6-1 – 12

602.1, 602.2 (New), 602.2.1, 602.2.2, 602.2.2.3, 602.3, 602.3.1 (New), 602.3.2 (New), 602.3.3 (New), 602.3.4 (New), 602.4, 602.5, 602.6,

Proponent: Kim Paarlberg, International Code Council

FIG. 610.2
BATHTUB SEATS

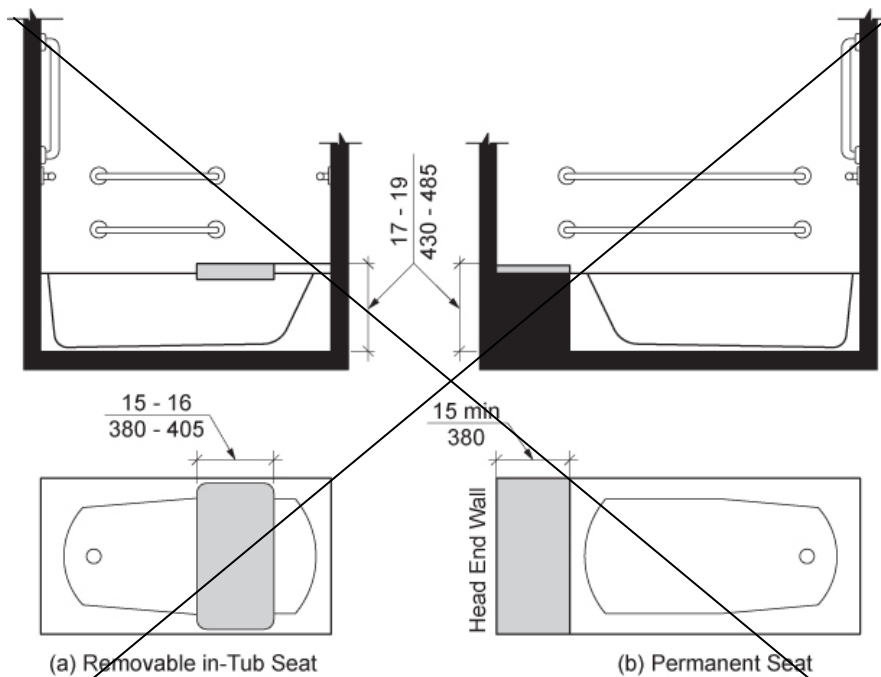
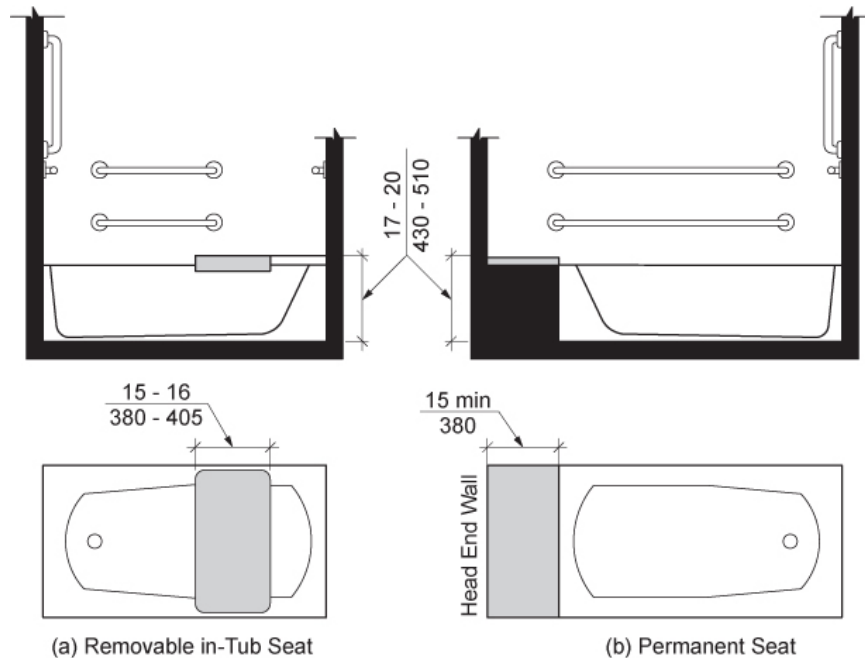
NOTE: This change necessitates a change to Fig. 610.2 to ensure consistency. Thus, the proposed revised figure has been attached, along with the existing figure for comparison purposes.

610.2 Bathtub Seats. The height of bathtub seats shall be 17 inches (430 mm) minimum and ~~19~~ 20 inches (485 510 mm) maximum above the bathroom floor, measured to the top of the seat. Removable in-tub seats shall be 15 inches (380 mm) minimum and 16 inches (405 mm) maximum in depth. Removable in-tub seats shall be capable of secure placement. Permanent seats shall be 15 inches (380 mm) minimum in depth and shall extend from the back wall to or beyond the outer edge of the bathtub. Permanent seats shall be positioned at the head end of the bathtub.
